MEMORANDUM

To: Planning Commission
 From: Community Development Department
 Subject: Rees Capital Office Site Plan Review
 1680 E. Dimple Dell Road
 [Community # 22]

Zone PO
 SPR-02-20-5798
 0.52 Acres

Project Name: Rees Capital Office
Plan Case Number: SPR-02-20-005798
Project Address: 1680 Dimple Dell Road

EXTERIOR ELEVATIONS
DRAWING NUMBER
A202A

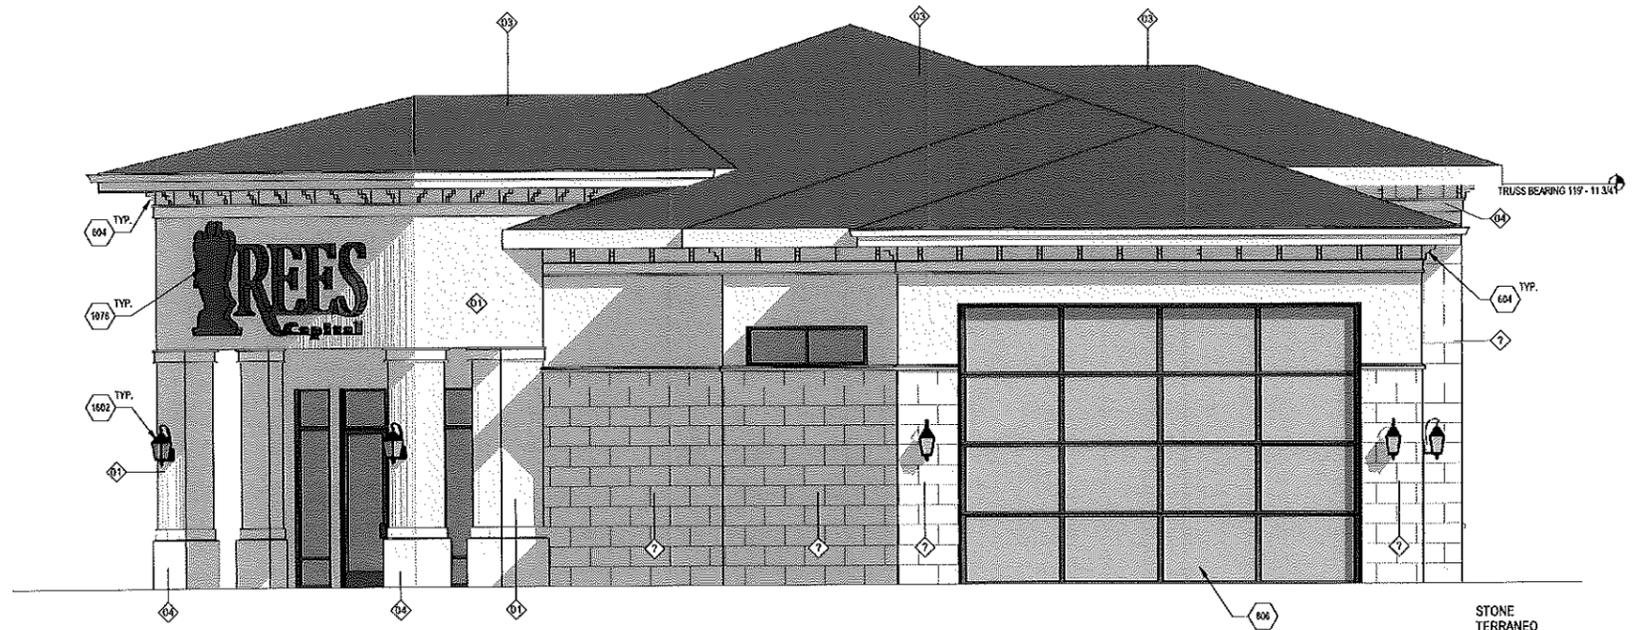
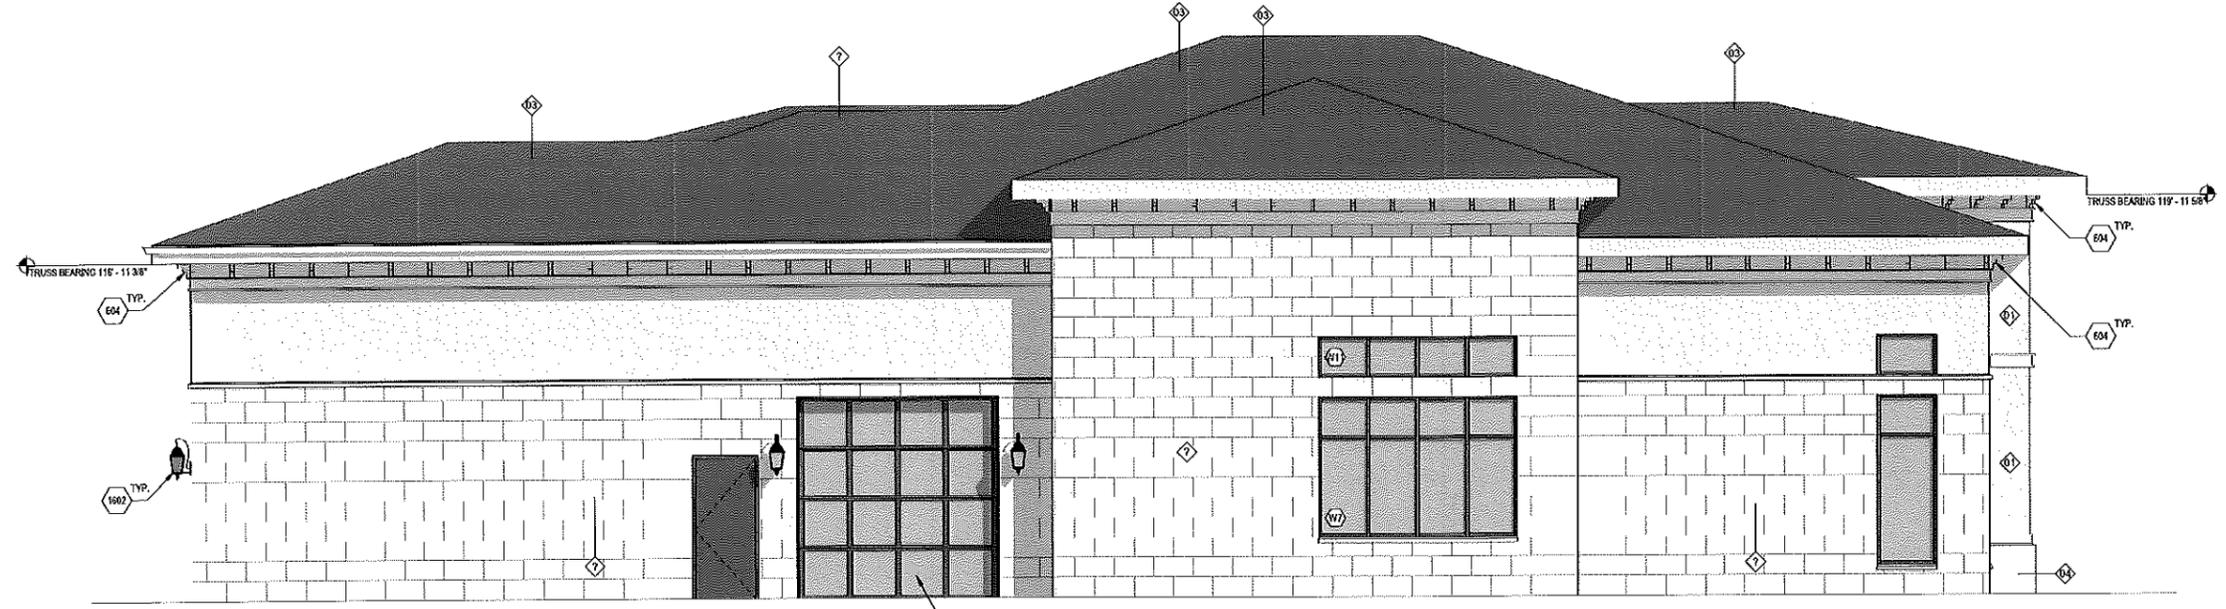
Building Architectural Design, Materials & Colors. The building architectural design, materials and colors meet the requirements of the Sandy City Architectural Design Standards, **EXCEPT for the percentage limit on stucco/EIFS being less than 20 percent on three of the four sides of the proposed building. (See the applicant's attached justification letter.)**

- Requesting that the Planning Commission approve the exterior building materials to include the use of Stucco/EIFS in excess of the code requirement of less than 20 percent per each of three of the four building faces. Percentages range from 25 to 34 percent stucco/EIFS.
- Requesting that the Planning Commission determine that the use of garage doors on two sides of the attached garage exceed the height of normal residential garage doors, up to 14 feet in height.
- Requesting the Planning Commission to not require street trees to be installed along Dimple Dell Road or along 1700 East Street.

Staff's Issues with Requested Deviations from the Sandy City Code. Staff supports the applicant's proposal to use higher value Terro Neo type stucco/EIFS in excess of the 20 percent per building face on three of the four building elevations. The use of Terro Neo has been approved by the Planning Commission on numerous occasions and if properly installed, has the appearance of large sheets of natural cut stone.

7. That the architectural design, colors and materials proposed for this development and as approved by the Planning Commission as complying with the Sandy City Architectural Design Standards be finalized with staff prior to the issuance of a building permit, including the use of Terro Neo type stucco/EIFS in excess of 20 percent per building face, as shown on the architectural elevations of the building.
